## CSP 26-036KB (BP048) – ADDENDUM No.02 BP048 HVAC – MEP West Zone 3

## FBISD BP048 HVAC - MEP WEST ZONE 3 25241.0100

Addendum #: 002

Addendum No.2 provides clarifications and revisions to the sheets as outlined below. See MEP narratives for their respective summaries.

A-M10-01

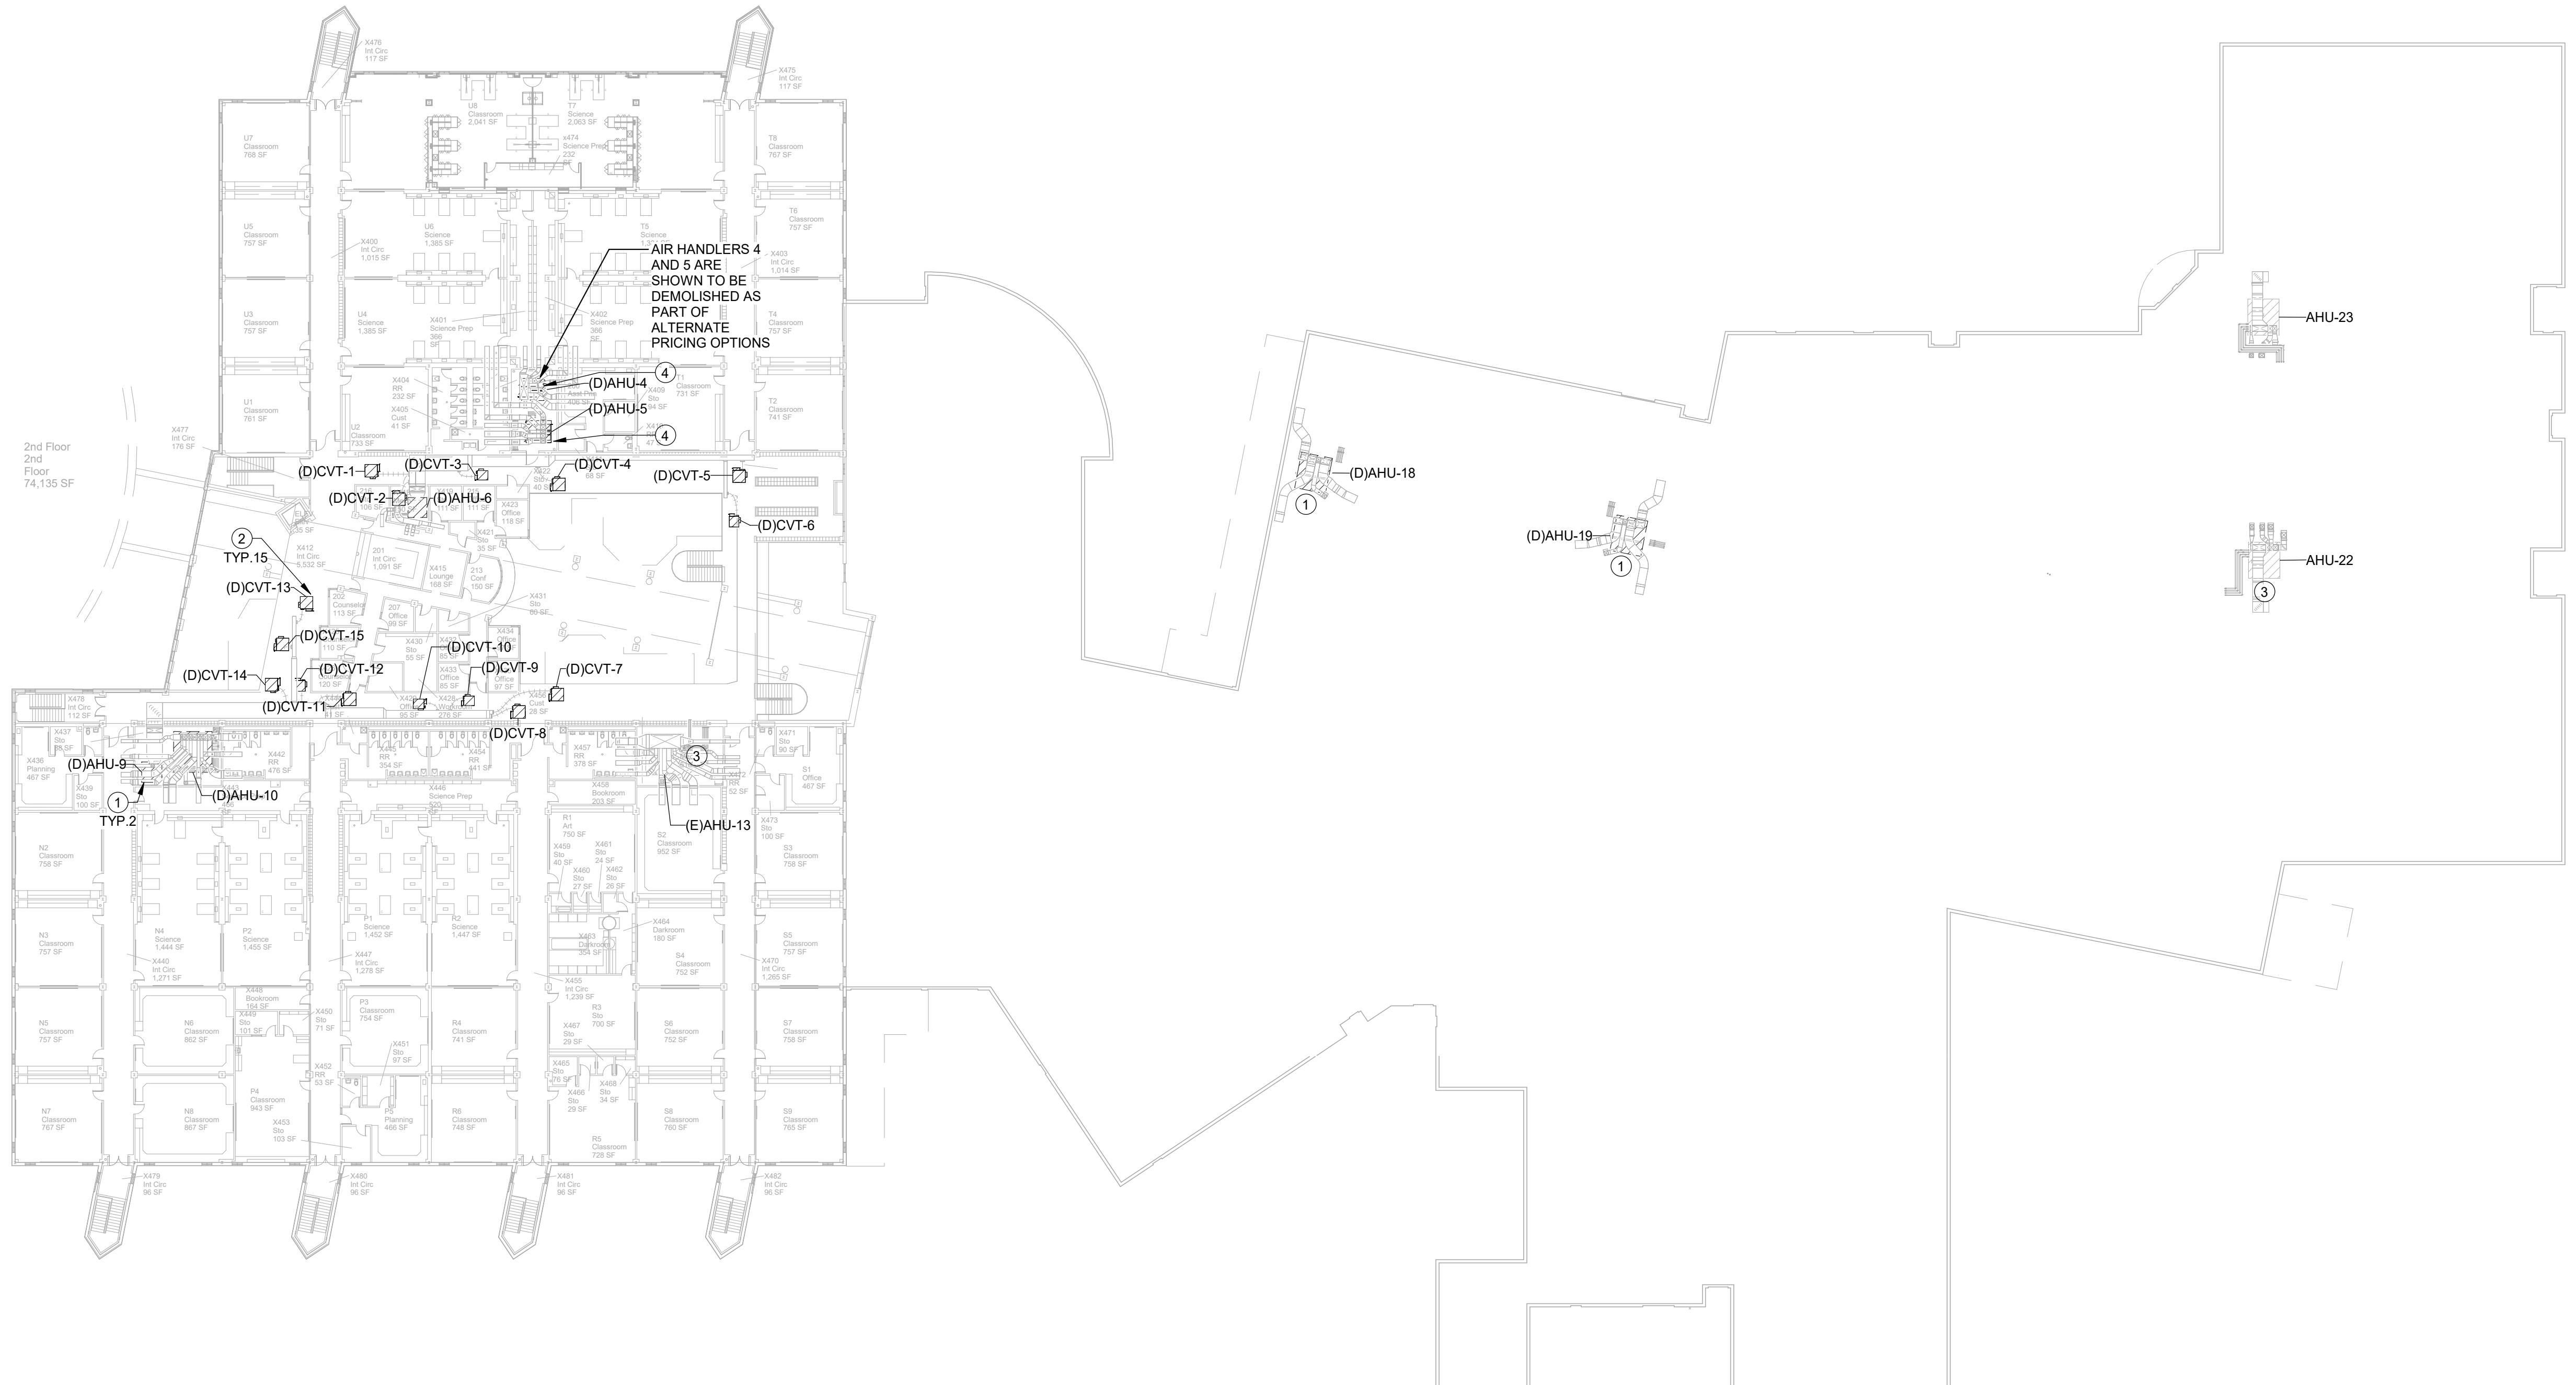
- A-M10-01 - MECHANICAL DEMOLITION PLAN - LEVEL 01 – OVERALL
  - Updated Keynote 2 to clarify the demolition scope
- A-M10-02 - MECHANICAL DEMOLITION PLAN - LEVEL 02 – OVERALL
  - Updated Keynote 2 to clarify the demolition scope
- A-M20-01 - MECHANICAL PLAN - LEVEL 01 – OVERALL
  - Added Controls to be by Unify Controls note
- A-M20-02 - MECHANICAL PLAN - LEVEL 02 – OVERALL
  - Added Controls to be by Unify Controls note
- A-M20-03 - MECHANICAL ENLARGED PLANS
  - Added Controls to be by Unify Controls note
- A-M20-04 - MECHANICAL ENLARGED PLANS
  - Added Controls to be by Unify Controls note
- A-M20-05 - MECHANICAL ENLARGED PLANS
  - Added Controls to be by Unify Controls note
- A-M30-00 - MECHANICAL SCHEDULES
  - Added a pump alignment note to the pump schedule
- A-M40-01 - MECHANICAL DETAILS
  - Added a note for the unit dimensions and field adjustments to be made by contractors

2. REMOVE AND DEMOLISH EXISTING TERMINAL UNIT. DEMOLISH FLEX CONNECTIONS, COILS AND ASSOCIATED PIPING, ASSOCIATED CONTROLS ACTUATORS AND SENSORS. MAKE READY ALL CONNECTIONS FOR INSTALLATION OF NEW TERMINAL UNIT AND CONTROLS. CONTROLS CONTRACTOR TO SECURE ALL EXISITNG CONTROLS RELATED INFORMATION, INCLUDING BUT NOT LIMITED TO SEQUENCE OF OPERATIONS, ETC. PRIOR TO ANY DEMOLITION OF EQUIPMENT. CONTRACTOR TO REMOVE PROTECT AND REINSTALL ANY CEILING GRID AND TILE NECESSARY TO PROPERLY DEMOLISH EXISITNG TERMINAL UNIT AND MAKE READY FOR NEW TERMINAL UNIT INSTALLATION.

### MECHANICAL PLAN - LEVEL 01 - OVERALL

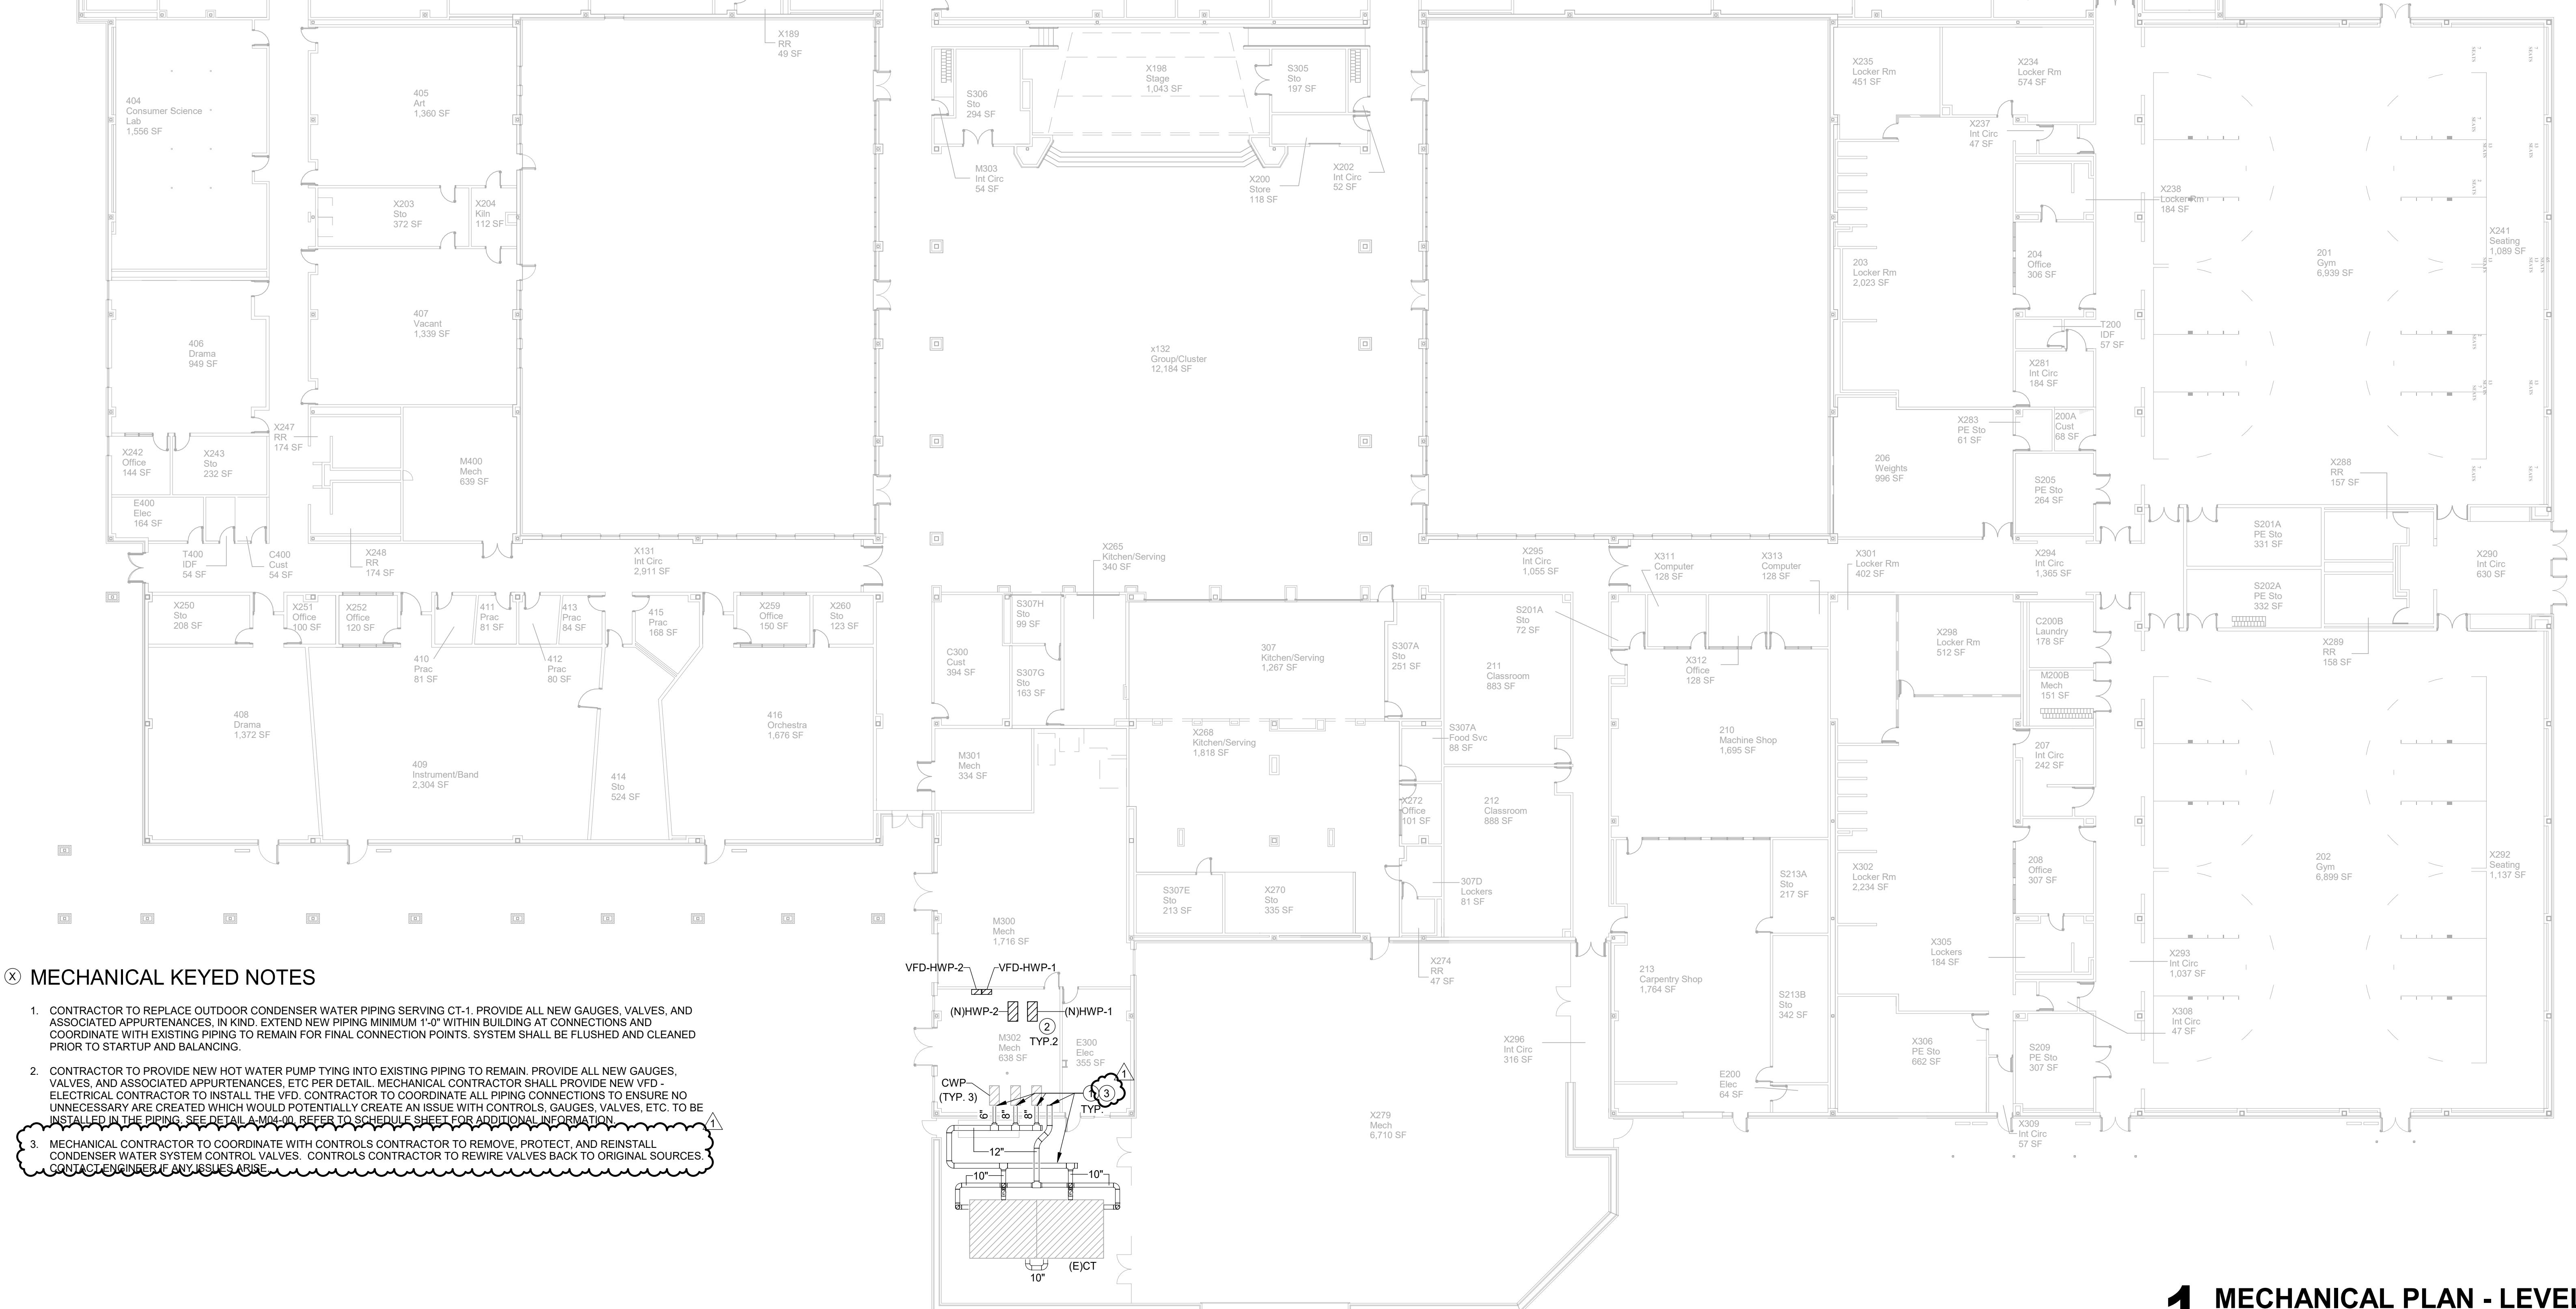
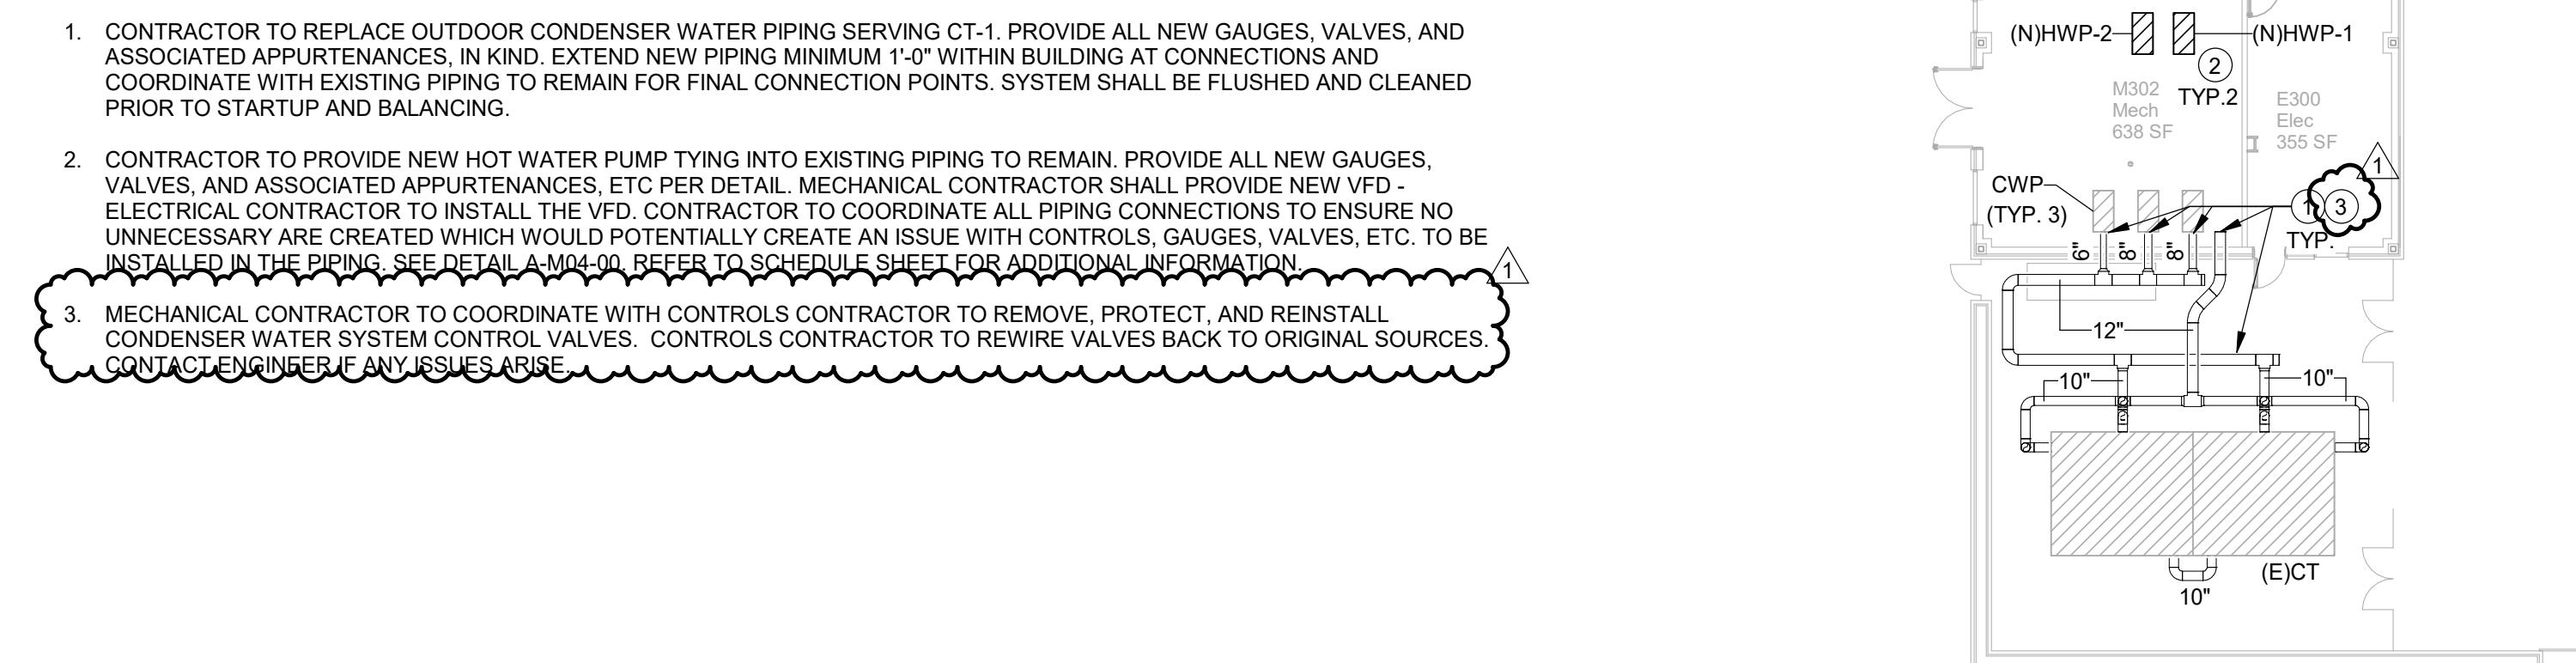
- B-M20-01 - MECHANICAL PLAN - LEVEL 01 - OVERALL
  - Added a keynote telling contractor to replace cooling tower bypass line
- B-M30-00 - MECHANICAL SCHEDULES
  - Added a pump alignment note to the pump schedule

- Contractor to replace entire condenser water cooling tower bypass line header (approximately 8') from bottom elbow where piping runs underneath the tower to each basin, including isolation valves at each tower. Paint to match existing piping.

- C-M20-01 - MECHANICAL PLAN - LEVEL 01 - OVERALL
  - Added a keynote telling mechanical contractor to coordinate with controls contractor on CT Valve protection.
- C-M30-00 - MECHANICAL SCHEDULES
  - Added a pump alignment note to the pump schedule

3. MECHANICAL CONTRACTOR TO COORDINATE WITH CONTROLS CONTRACTOR TO REMOVE, PROTECT, AND REINSTALL CONDENSER WATER SYSTEM CONTROL VALVES. CONTROLS CONTRACTOR TO REWIRE VALVES BACK TO ORIGINAL SOURCES. CONTACT ENGINEER IF ANY ISSUES ARISE.

## SCHEDULE OF PUMPS

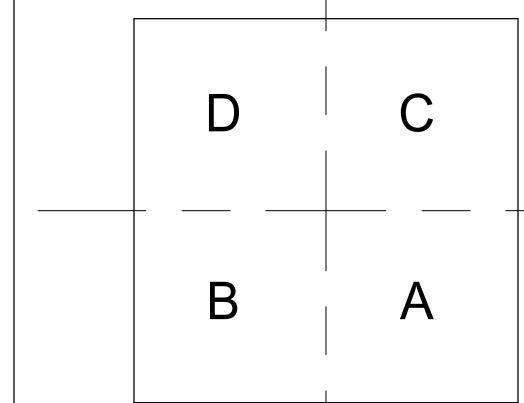
- G-M30-00 - MECHANICAL SCHEDULES
  - Added a pump alignment note to the pump schedule

- H-M30-00 - MECHANICAL SCHEDULES
  - Added a pump alignment note to the pump schedule

6. CONTRACTOR SHALL VERIFY PUMP BODY DISCHARGE PIPING CONNECTION TO ENSURE ALIGNMENT WITH PIPING OR ADJUST PIPING AS REQUIRED WHILE MAINTAINING APPURTENANCES AS SHOWN IN THE DETAILS.
